Application for Licence Amendment

Licence Number	L9155/2018/1
Licence Holder	Avoca Mining Pty Ltd
ACN	108 547 217
File Number	DER2018/001153~5
Premises	Higginsville Gold Project HIGGINSVILLE, WA, 6443 M15/351, M15/289, M15/225, M15/642, M15/348, M15/31, M15/786, M15/506, M15/507, M15/620, M15/629, M15/639, M15/640, M15/580, M15/581, M15/597, L15/225, L15/288, L15/302, G15/19, G15/23, M15/528, M15/231, M15/748, M15/512, M15/352, M15/610, M15/375, M15/338, M15/1790, M15/1814, L15/282, L15/347, G15/26, G15/27, G15/29, L15/382, L15/389, M15/325, M15/681 and M15/817.
Date of Report	22 September 2021
Decision	Revised licence granted

This Amendment Report documents the assessment of potential risks to the environment and public health from proposed changes to the emissions and discharges during the operation of the Premises. As a result of this assessment, Revised Licence L9155/2018/1 has been granted.

Figure 1: Water levels in m RL (black lines) as compared to licence limit

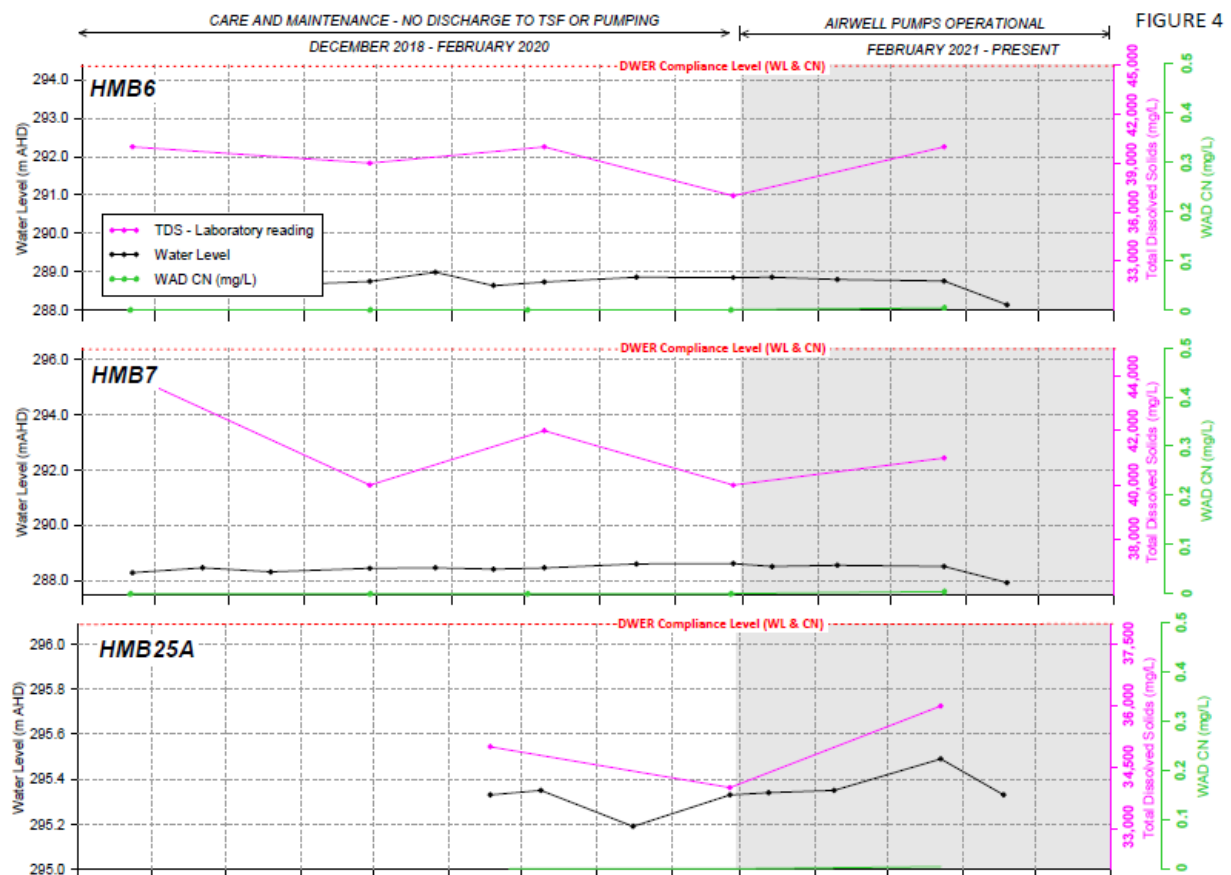
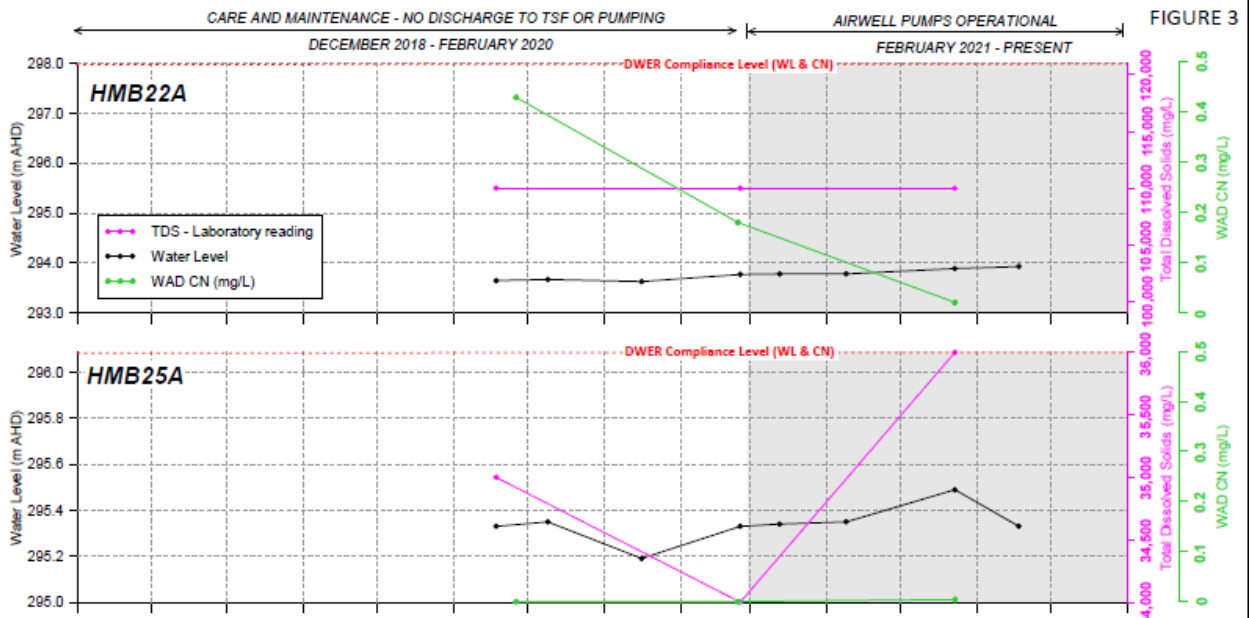
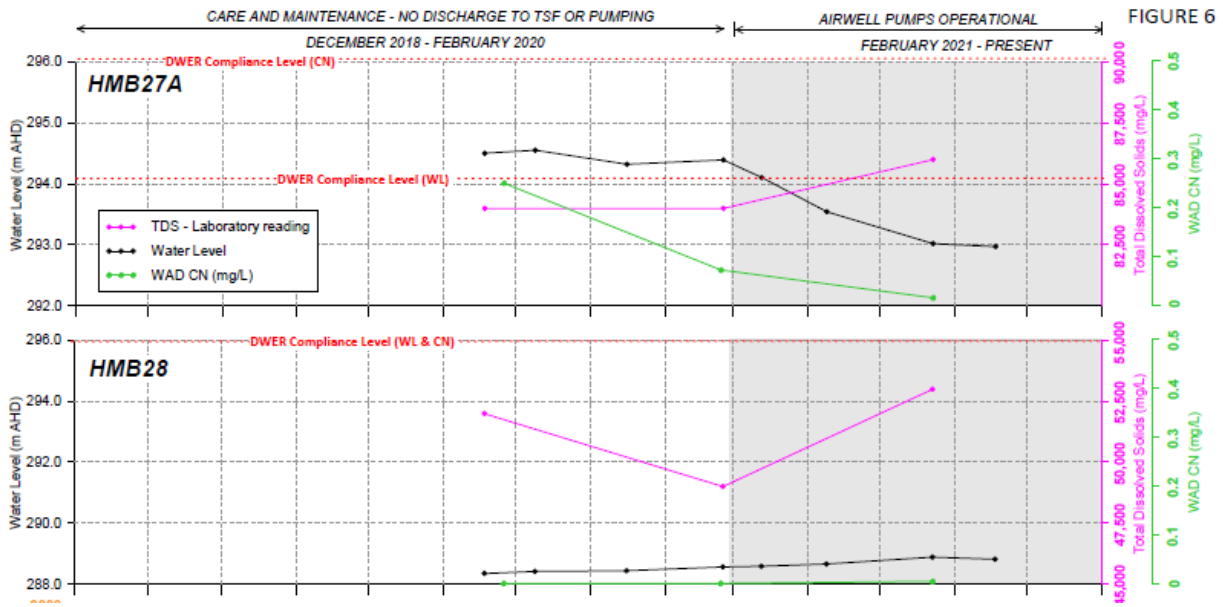
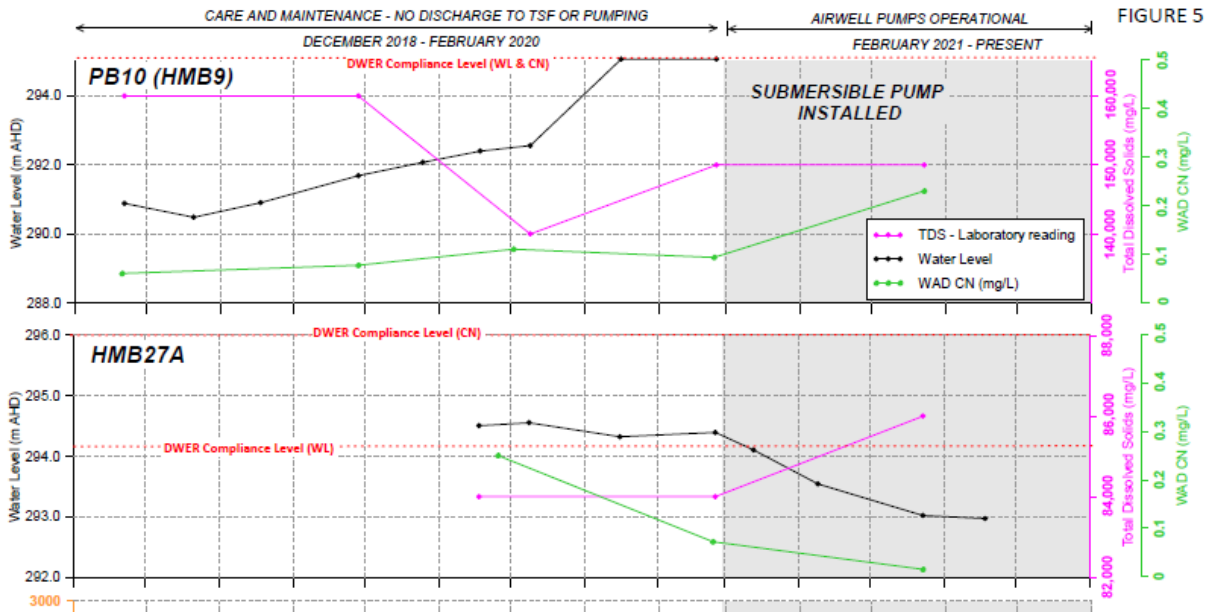
A report was provided to the Department in July 2021 (Rockwater, July 2021a) that assessed the results of the seepage recovery for the TSF 2-4 as established under the Premises' Groundwater Recovery and Seepage Management Plan (Rockwater, July 2021b). The report was sufficient to demonstrate that there has been a reduction in standing water levels across most monitoring bores except for the bores HMB22A and HMB28 (Figure 1) as a result of implementing the seepage recovery measures. The increases in bores HMB22A and HMB28 was not significant enough to exceed the licence limit of 4 metres below ground level (mbgl).
